STAFF REPORT

MEETING DATE: December 10, 2024

AGENDA ITEM TITLE: Ricci Minor Subdivision – Limited Impact Review

RICCI MINOR SUBDIVISION

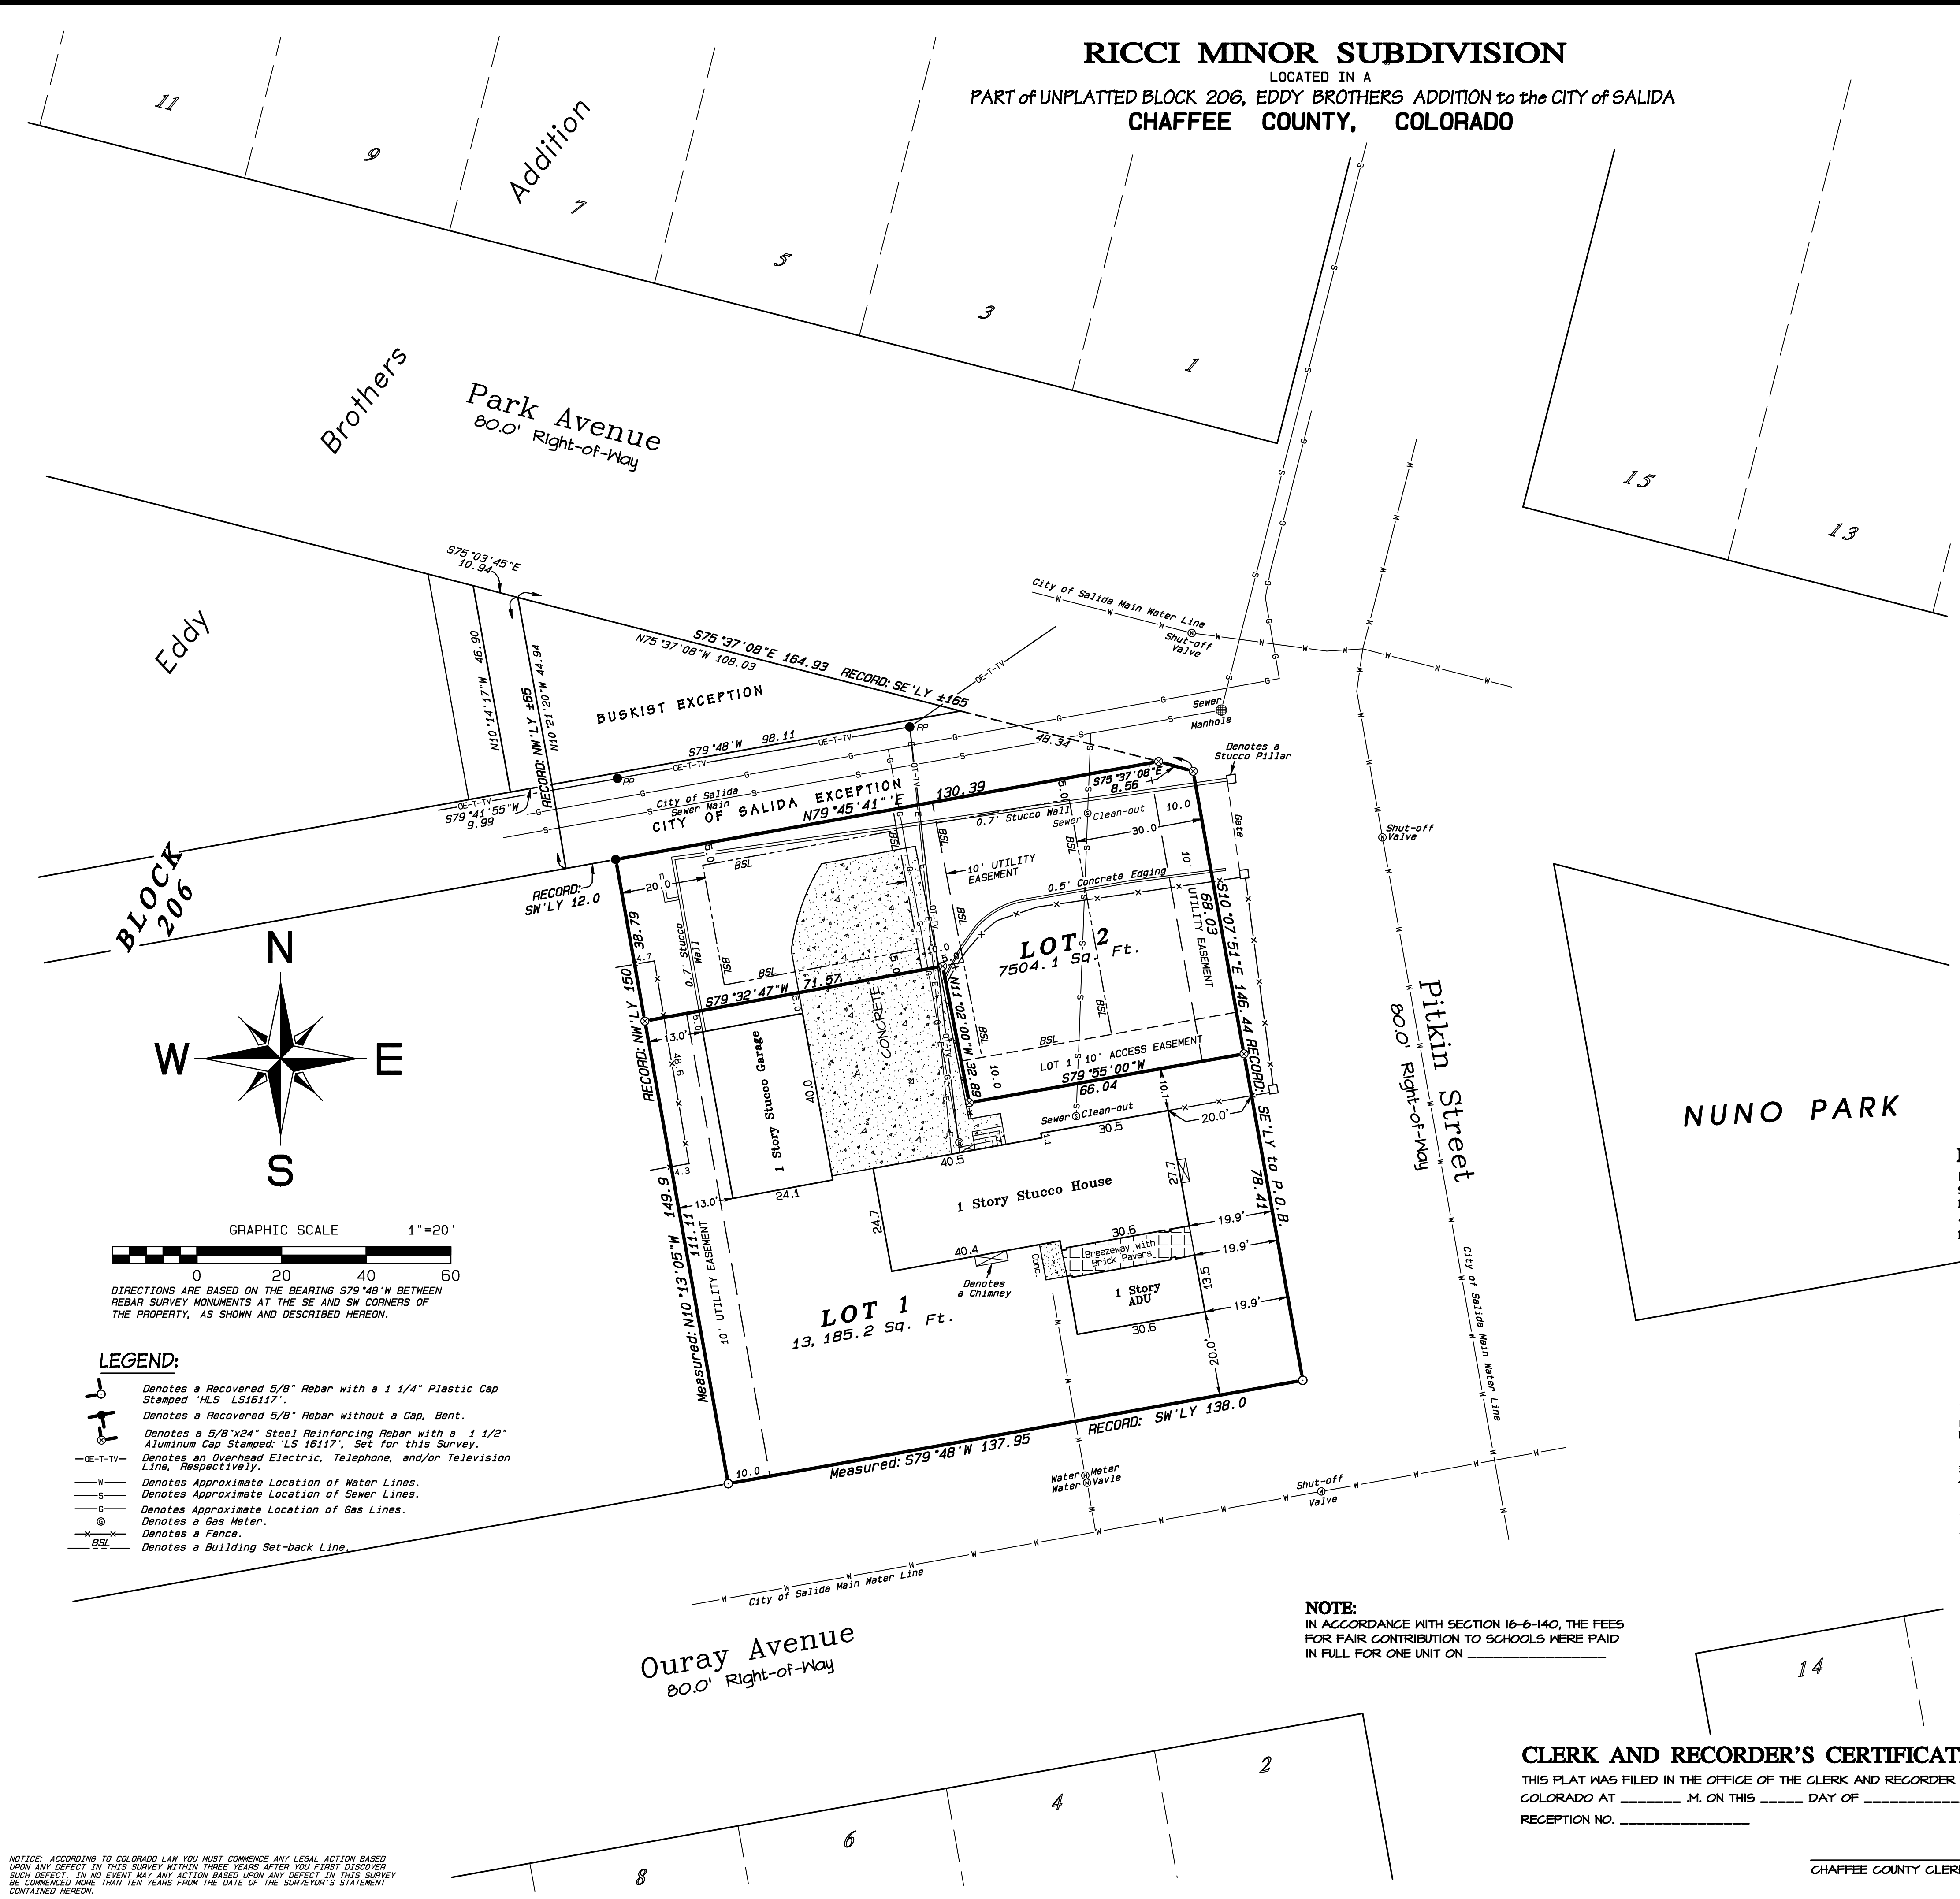
- 4) Xcel Energy has commented on the need for a utility easement across lot 2 of the subdivision, or rerouting of the lines. They stated the property owner/developer/contractor may either obtain an easement for this line or relocate the line. For an easement by separate Public Service Company document, a Right-of-Way Agent must be contacted.

- Xcel Energy has commented on the need for a utility easement or rerouting of electrical lines prior to development of Lot 2.
 - c. **Phases.** If the subdivision is to be developed in phases, each phase shall contain the required parking spaces, landscape areas, utilities and streets that are necessary for creating and sustaining a stable environment.

Xcel Energy: “Public Service Company of Colorado’s (PSCo) Right of Way & Permits Referral Desk has reviewed the minor subdivision for Ricci Minor Subdivision and has a conflict with the lot split. Please be aware PSCo owns and operates existing overhead electric service facilities through Lot 2 to Lot 1. The lot split places the current service line in trespass through new Lot 2.

The property owner/developer/contractor may either obtain an easement for this line or relocate the line.

1. Provide the following notes on the minor subdivision plat prior to recording:
 - a. Utility easements are dedicated to the City of Salida for the benefit of the applicable utility providers for the installation, maintenance, and replacement of electric, gas, television, cable, and telecommunications facilities (Dry Utilities). Utility easements shall also be granted within any access easements and private streets in the subdivision. Permanent structures, improvements, objects, buildings, wells, water meters and other objects that may interfere with the utility facilities or use thereof (Interfering Objects) shall not be permitted within said utility easements and the utility providers, as grantees, may remove any Interfering Objects at no cost to such grantees, including, without limitation, vegetation. Public Service Company of Colorado (PSCo) and its successors reserve the right to require additional easements and to require the property owner to grant PSCo an easement on its standard form.

2. The applicant should confirm with Xcel Energy and Atmos Energy the appropriate width of the utility easement within the Lot 2 property, or relocate utilities as necessary, and amend the subdivision plat if necessary prior to recordation.
